# HUELLMANTEL AFFILIATES

## MEMORANDUM

To: Cassidy Welch, City of Mesa - Planning Division  
From: Charles Huellmantel, Huellmantel & Affiliates  
Re: Millennium Superstition Springs - ZON22-00431 & DRB22-00644  
Date: July 18, 2022

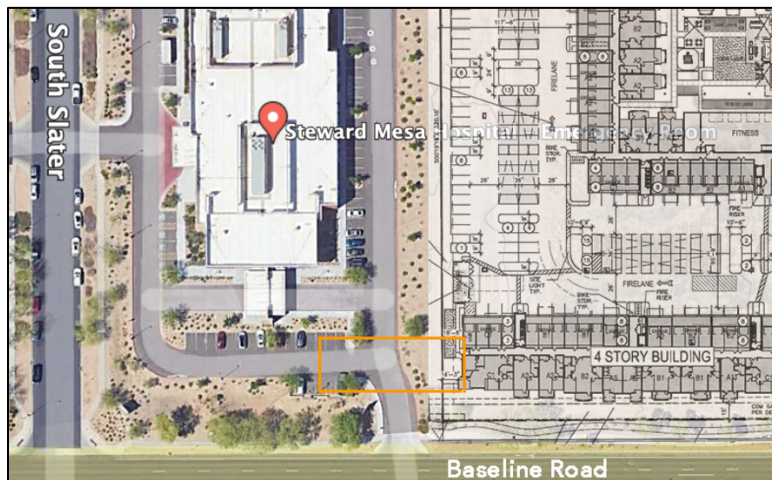
Revise the landscape plan to include counts for percentages.

The quantity and size of tree provided have been listed on the landscape plan. Additionally, notes regarding the tree size and quantity percentages are shown on the plan:

- \*(2) ADDITIONAL 24" BOX TREES SUBSTITUTED FOR (4) 15 GALLON TREES
- \*\* (3) 24" BOX SUBSTITUTED FOR (6) 15 GALLON TREES

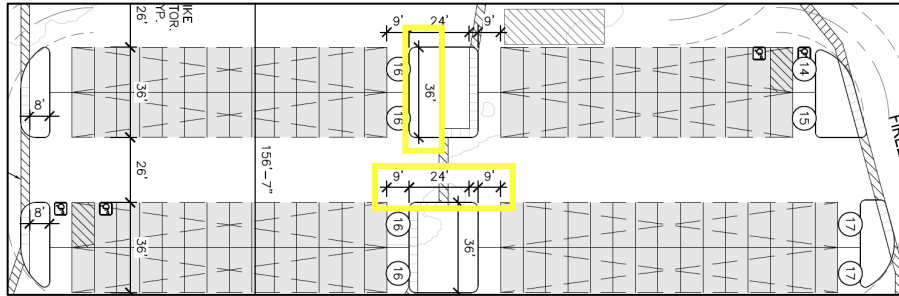
5. Repeat. Per MZO Section 11-33-3.B.2, non-single residence uses adjacent to non-residential districts and/or uses shall provide a 15-foot landscape yard. A deviation has been requested as part of the PAD overlay

- a. Revise the project narrative to include sufficient justification for the reduced setback. Staff has concerns with the proposed reduction.

The only landscape yard that is less than 15 feet adjacent to a non-residential use is the rear / west side:

This yard setback is proposed at 10 feet but the actual closest building to the adjacent use is approximately 14 feet, 3 inches from the property line, which is less than 1 foot shorter than required. The justification is included in the narrative.

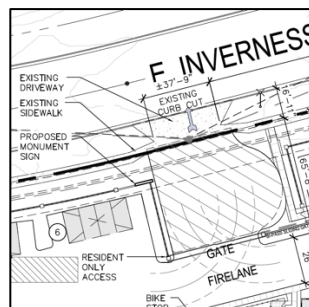
1. Gated driveway entrances shall be per COM 2021 Std Dtl M-42.01 or M-42.02 or provide an acceptable alternative design that allows vehicles that are denied entrance a means of turning around. Please callout the keypad location. The number of units required a 100' storage between the keypad and the ROW. The Inverness Ave access will require a turn-around area as well - even if for residents only. The main entry gates off Baseline Rd should be pushed into the site further to allow for better circulation and less congestion around the Clubhouse and leasing office.

As you can see in the image below, a turnaround has been provided for residents on Inverness Avenue:

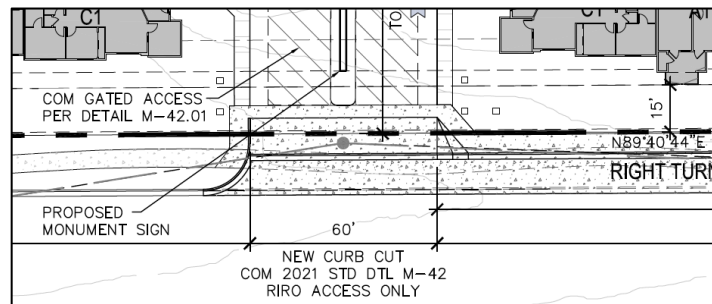
3. *Verify ROW and PUF (Baseline Rd requires 65' ROW & 8' PUF, Sunview requires 55' ROW & 8' PUF and Inverness Ave requires 40' ROW & 8' PUF) and if not meeting current code requirements, dedicate to meet City of Mesa Detail M-19.01. All public facilities, including the sidewalk, driveways, and deceleration lanes, shall reside within the public domain - this may require additional dedications.*

*We will comply with this requirement during the construction document phase.*

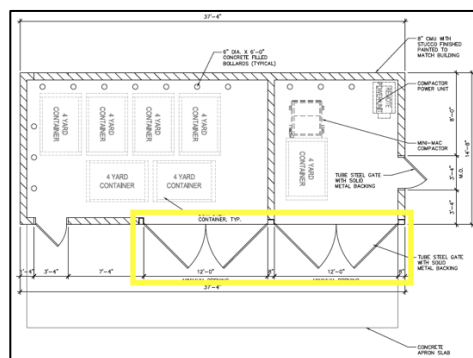
*Solid waste comments are located on - "Millennium - Baseline & Sunview - Site Plan and Details 6-1..."*

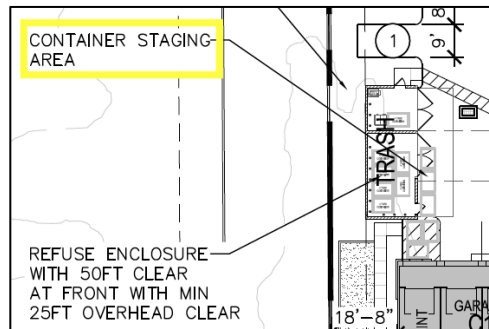
2. The net width opening for both enclosures between the gates must be 12'.

Each refuse gate opening is shown as 12 feet:

**July 2022 (current) Building 3 elevation:**

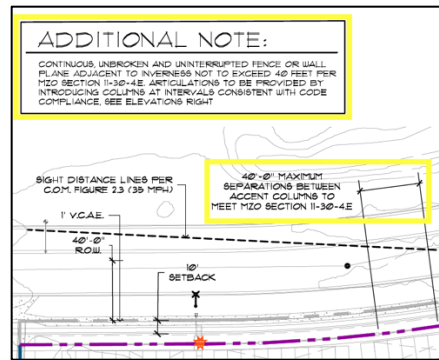
2. Provide color elevations, site lighting, photometrics and renderings with the resubmittal.  
In color elevations, renderings, site lighting and photometrics are included in this formal submittal package.
3. Per MZO Section 11-5-5.B.4, when multiple garage doors are located within one building, the maximum number of garage doors adjacent to one another shall be limited to three unless

there is a break in the building façade between garage doors. The proposed elevations do not comply. Please address or revise the PAD table accordingly.

An additional break in the building has been added to Building 3 (all levels), which creates more variation and visual articulation:
